PRODUCT IMPROVEMENT

## RPB, RPA and RPC Commercial Two Speed Coolers

WALL SWITCH

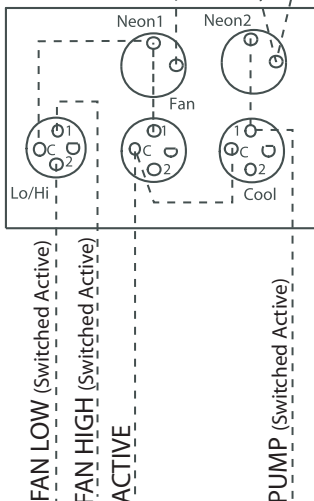
Due to pending changes in some state safety regulations, as well as energy management becoming increasingly important to all Australian business Braemar Commercial 2 speed wall switches will now come standard with 2 Green Neon Indicators.

The individual neon's on the wall switch will illuminate to indicate when either the pump (cool) or the fan motor (fan) has been switched on. This will allow office and factory personnel to identify at a glance if the Coolers fan or pump are running.

All coolers manufactured from Serial Number C0902xxxx will have the new wall switch included.

**New Wire Required**

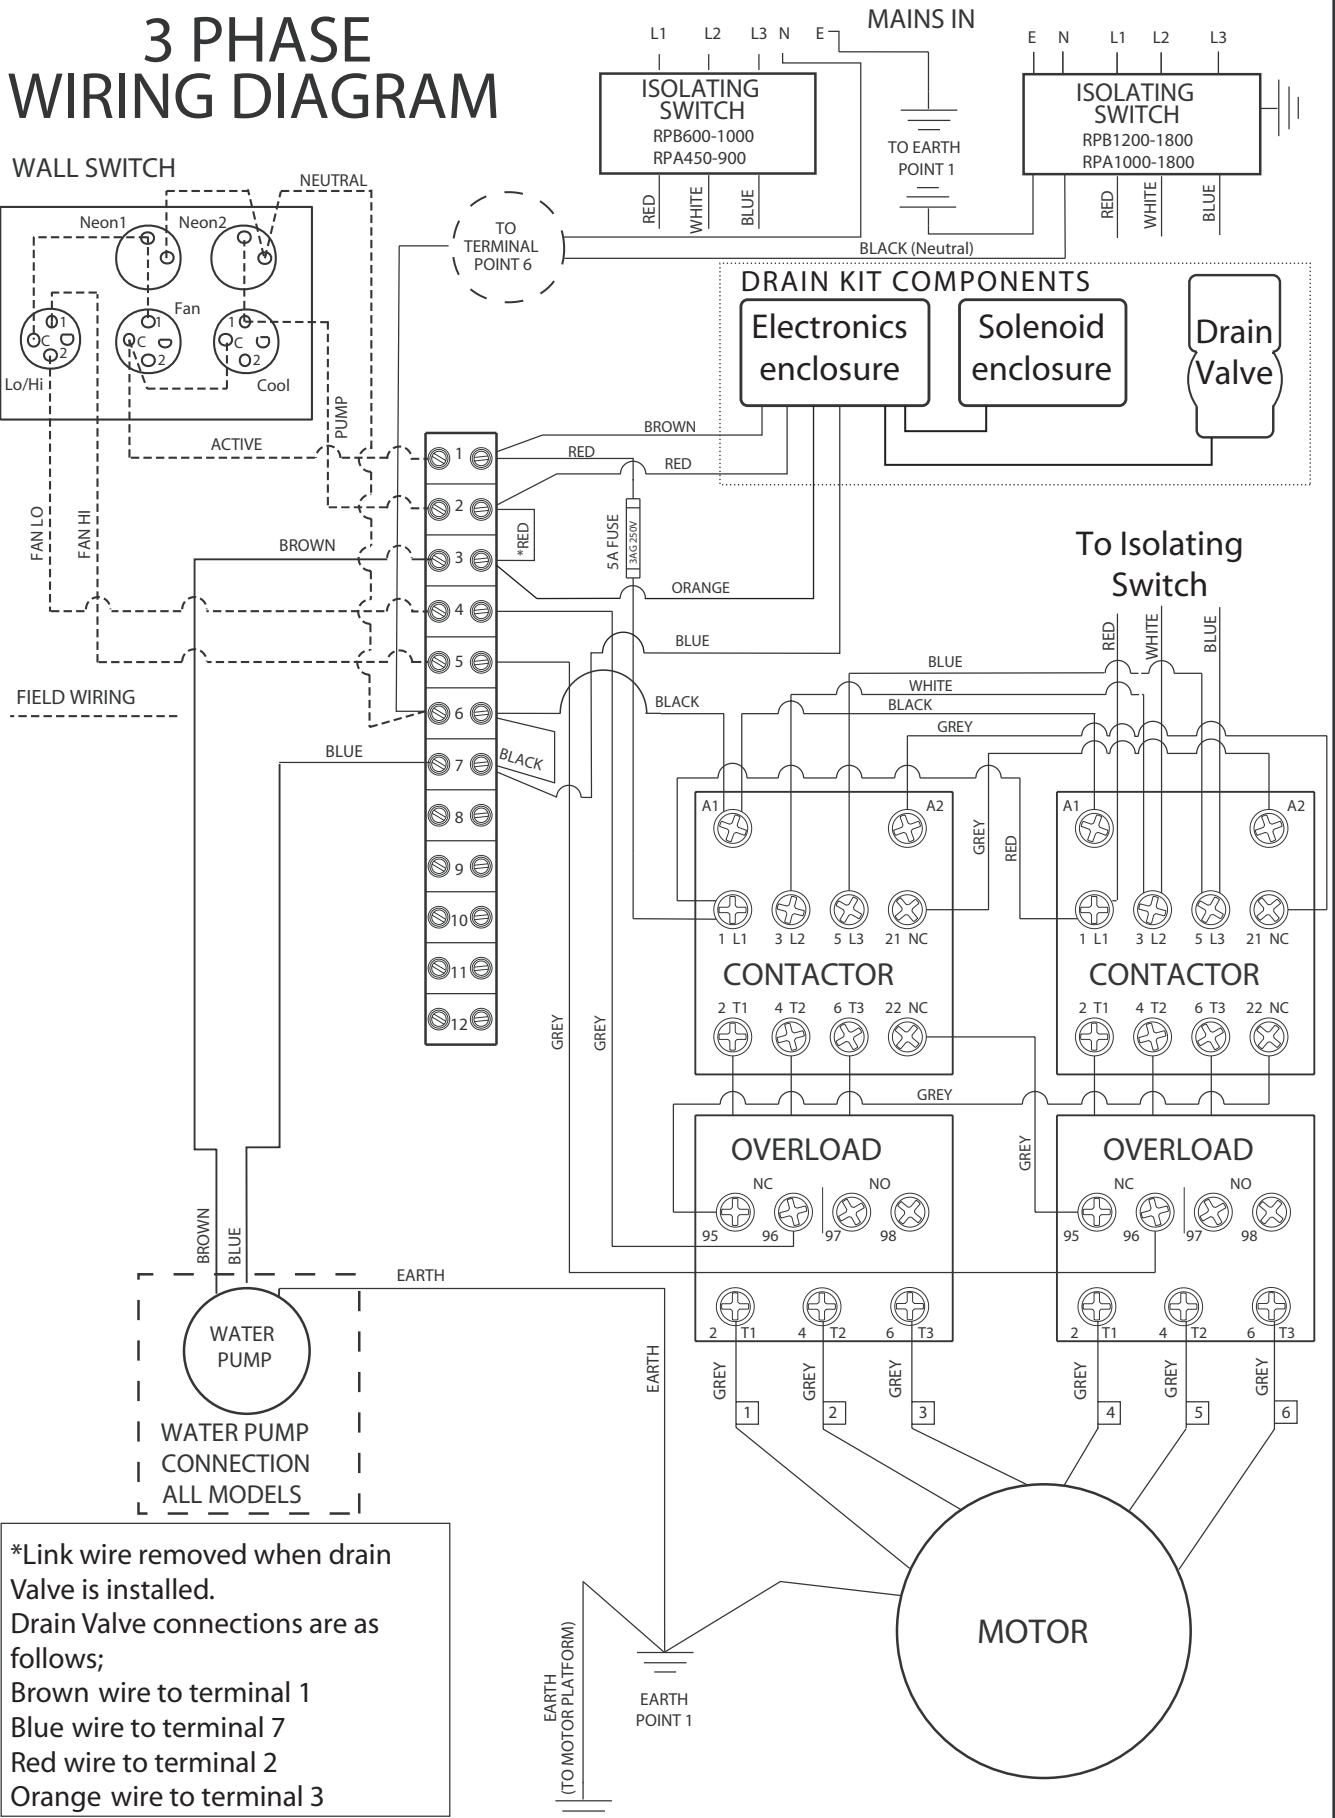
Required wiring from the cooler control box to the wall switch.

- Active x 1
- Switched Active x 3
- Neutral x 1

# 3 PHASE WIRING DIAGRAM

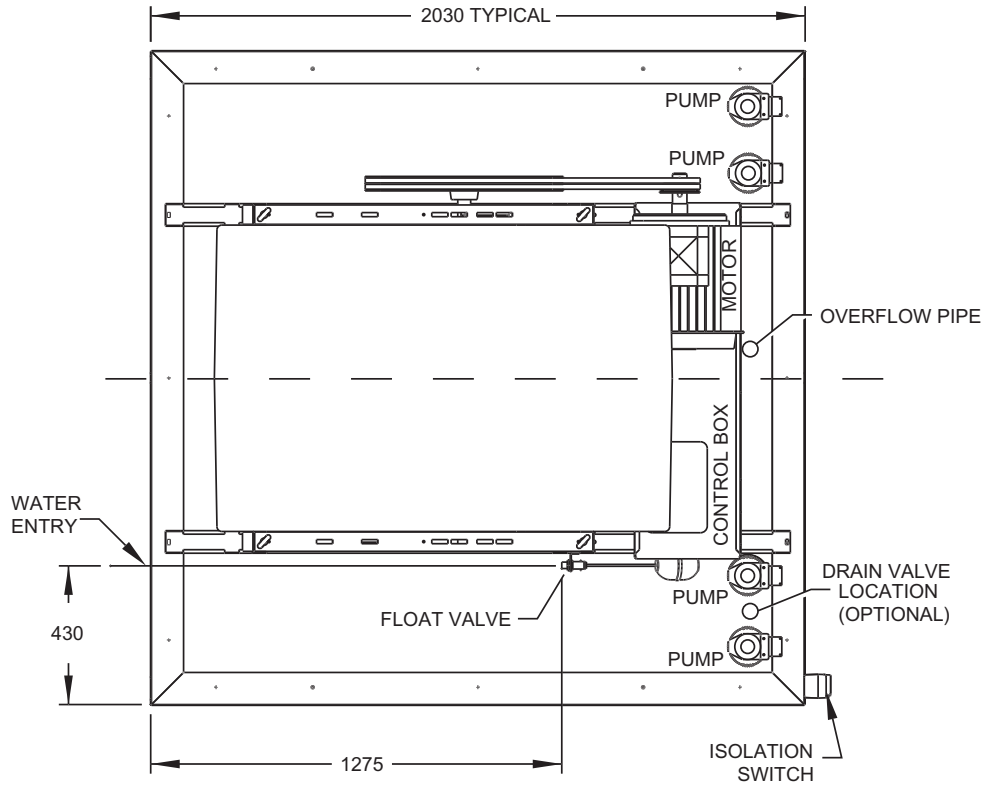
**THESE WIRING INSTRUCTIONS FOR UNITS MADE FROM MARCH 2009  
AFTER THE INTRODUCTION OF NEON INDICATORS**

\*Link wire removed when drain Valve is installed.  
Drain Valve connections are as follows;  
Brown wire to terminal 1  
Blue wire to terminal 7  
Red wire to terminal 2  
Orange wire to terminal 3
